Access Compliance Report

Public Rights-of-Way

Intersection ID: 13301	Main Street: S_TRYON_ST	Cross Street: W_CATHERINE_ST	Location: SW
ADA ID: 2B871D0808B9	Ramp Type: Perp	Initial Pass/Fail: Fail	Overall Compliance: No
		Severity Score: 12.5

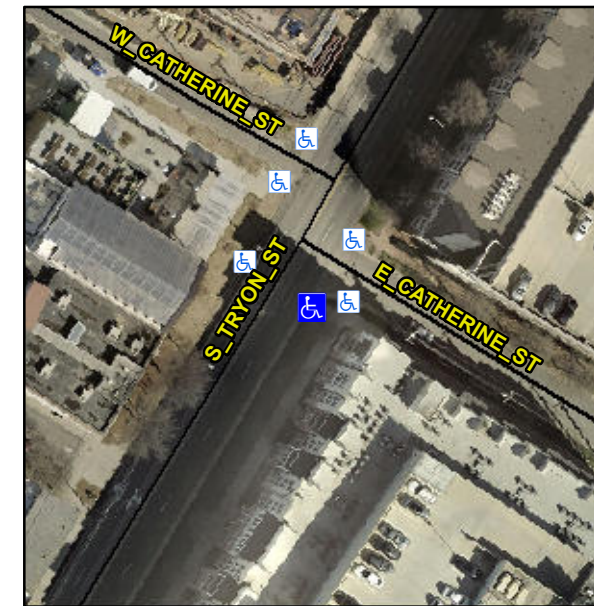
Not Found, R304.2.2

Compliance	Description	Data	Compliance	Description	Data
N/A	Ramp Length (in)	50.0	No	Ramp Slope (%)	8.7
Yes	Ramp Width (in)	48.0	Yes	Ramp XSlope (%)	1.1
N/A	Flare Type LT	N/A	N/A	Flare Type RT	N/A
N/A	Flare Slope LT (%)	N/A	N/A	Flare Slope RT (%)	N/A
N/A	Flare Traversable LT?	N/A	N/A	Flare Traversable RT?	N/A
N/A	Landing Length (in)	N/A	N/A	DWS Provided?	N/A
N/A	Landing Width (in)	N/A	N/A	DWS Contrast?	N/A
N/A	Landing Slope (%)	N/A	N/A	DWS Length (in)	N/A
N/A	Landing X Slope (%)	N/A	N/A	DWS Full Width?	N/A
N/A	Landing Curb? (Y/N)	N/A	N/A	DWS Offset (in)	N/A
N/A	Shared Landing?	N/A			
N/A	Gutter Ponding?	N/A	N/A	Gutter Slope (%)	N/A
N/A	Gutter Lip Ht (in)	N/A	N/A	Gutter X Slope (%)	N/A
N/A	Painted X Walk1?	No	N/A	Painted X Walk2?	N/A
	X Walk 1 Direction	To NW		X Walk 2 Direction	N/A
N/A	X Walk 1 Width (in)	N/A	N/A	X Walk 2 Width (in)	N/A
	X Walk 1 Slope (%)	2.2		X Walk 2 Slope (%)	N/A
	X Walk 1 X Slope (%)	2.8		X Walk 2 X Slope (%)	N/A

Remove & Replace Entire Ramp.
